Change of material, V-Lock cord retaining feature as standard.

Product Change Notification					PCN 4798		
owner	creation date	release date	released by	change order no	rev	page	0118.2322
hotzar	2015-12-05	2016-03-14	stadelt1	2009470	A	1 of 2

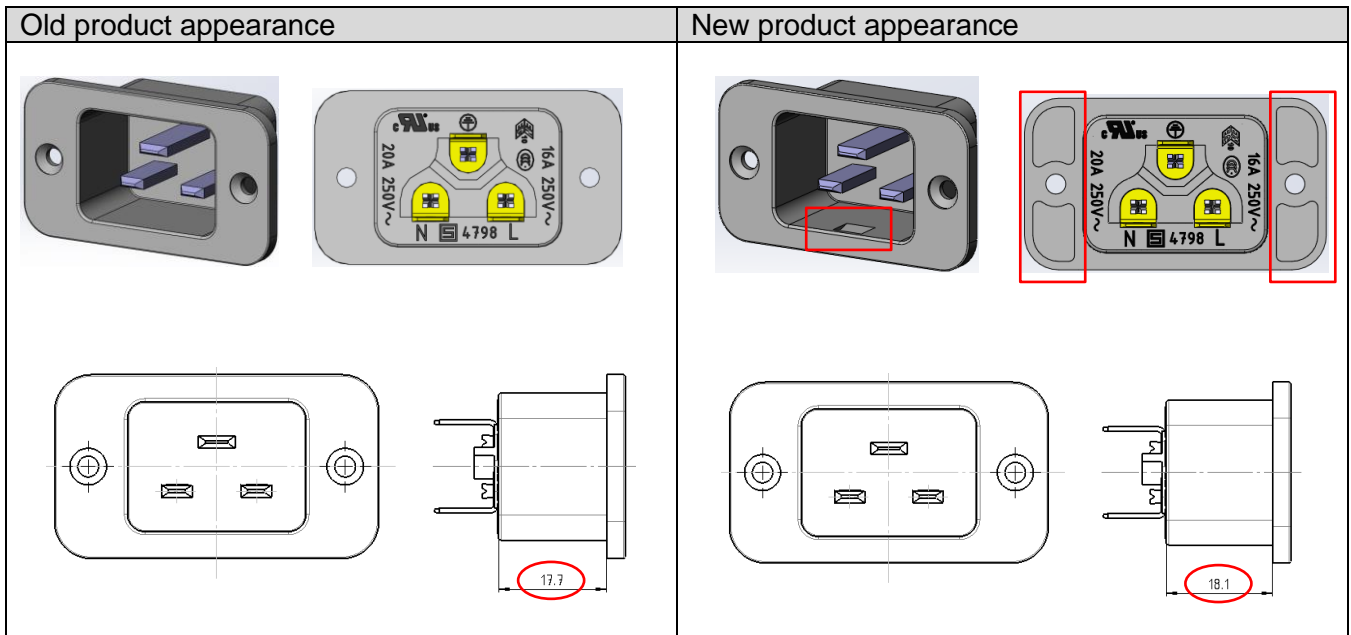
- Material change from PA6 to PA66/6 to pass the enhanced requirements of glow wire test acc. to IEC 60695-2-12 and -13
- V-Lock feature integrated as standard (not an option anymore)
- Flange will have a new form on the back side to improve molding process.

Form	Yes	Yes Socket has notch for V-Lock cord retaining, flange new form on the back side, extended socket dimension.
Fit	Yes	Yes, installation depth is 0.4 mm extended.
Function	Yes	V-Lock feature is standard (not an option anymore)
Production Site	No	There is no change of the production site
Product Label	No	No label change
Customer Action	No	Check installation depth in the application. Change SCHURTER part number if affected.

4798.9000.15 ⇒ 4798.9000	4798.9100.15 ⇒ 4798.9100	4798.9200.15 ⇒ 4798.9200
4798.9000.21 ⇒ 4798.9000	4798.9100.21 ⇒ 4798.9100	4798.9200.21 ⇒ 4798.9200
